APPLICATION NO.	FILING DATE	FIRST NAMED INVENTOR	ATTORNEY DOCKET NO.	CONFIRMATION NO.	
10/568,720	02/16/2006	Heiko Bald	GP-307708 9584		
286 GENERAL M	7590 02/21/2007 OTORS CORPORATION	EXAMINER			
LEGAL STAFF MAIL CODE 482-C23-B21 P O BOX 300 DETROIT, MI 48265-3000			GLUCHOWSKI, KRISTINA R		
			ART UNIT	PAPER NUMBER	
			3676		
SHORTENED STATUTORY PERIOD OF RESPONSE		MAIL DATE	DELIVER	DELIVERY MODE	
3 MC	ONTHS	02/21/2007	PAPER

<u></u> .		Application No.	Applicant(s)			
Office Action Summary		10/568,720	BALD, HEIKO			
		Examiner	Art Unit			
		Kristina R. Gluchowski	3676			
	The MAILING DATE of this communication appears on the cover sheet with the correspondence address Period for Reply					
WHIC - Exter after - If NC - Failu Any	ORTENED STATUTORY PERIOD FOR REPLY CHEVER IS LONGER, FROM THE MAILING DANSIONS of time may be available under the provisions of 37 CFR 1.13 SIX (6) MONTHS from the mailing date of this communication. period for reply is specified above, the maximum statutory period were to reply within the set or extended period for reply will, by statute, reply received by the Office later than three months after the mailing and patent term adjustment. See 37 CFR 1.704(b).

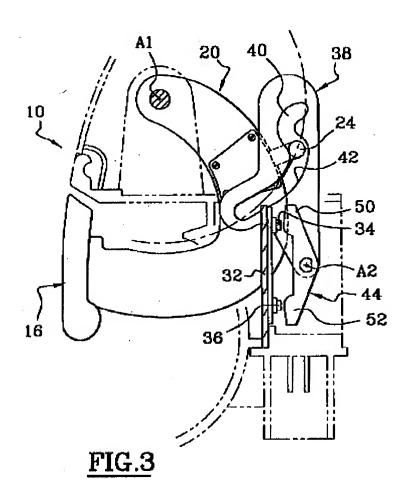
- 6. Claims 1-20 are rejected under 35 U.S.C. 102(b) as being anticipated by Suparschi (US 2001/0005082). Regarding claim 1, Suparschi shows a central locking system for vehicle doors comprising an electrical switch (34 and 44) for changing the central locking system to a locking or an unlocking state and an opening lever (16) which is pivotable disposed at an inside of a vehicle door (paragraph [0001]), for opening thereof wherein the switch is associated with the opening lever inside the door such that when the opening lever is pivoted out of an inoperative position into a first switched position, it effects a locking or an unlocking state of the central locking system and the locking or unlocking state is maintained until the opening lever is again pivoted into its switched position (see paragraphs [0061-62].

- 7. Regarding claim 2, "as best understood" when the opening lever is pivoted out of inoperative position into a mechanical opening position (see paragraph [0046]) the lever passes through a second switched position in which the switch generates a signal for changing the central locking system over to the unlocking state (see figure 4 for the unlocking position).

- 9. Regarding claims 5-8, the switch is "associated" in a rotationally rigid manner with a pivot pin (37) of the opening lever (paragraph [0051]).
- 10. Regarding claims 9-16, the opening lever automatically returns from its switched position and the opening position to its inoperative position (paragraph [0039]).
- 11. Regarding claims 17-20, the opening lever returns in a spring-loaded fashion to the inoperative position (see paragraph [0039]). See the Suparschi device below in the "inoperative" position.
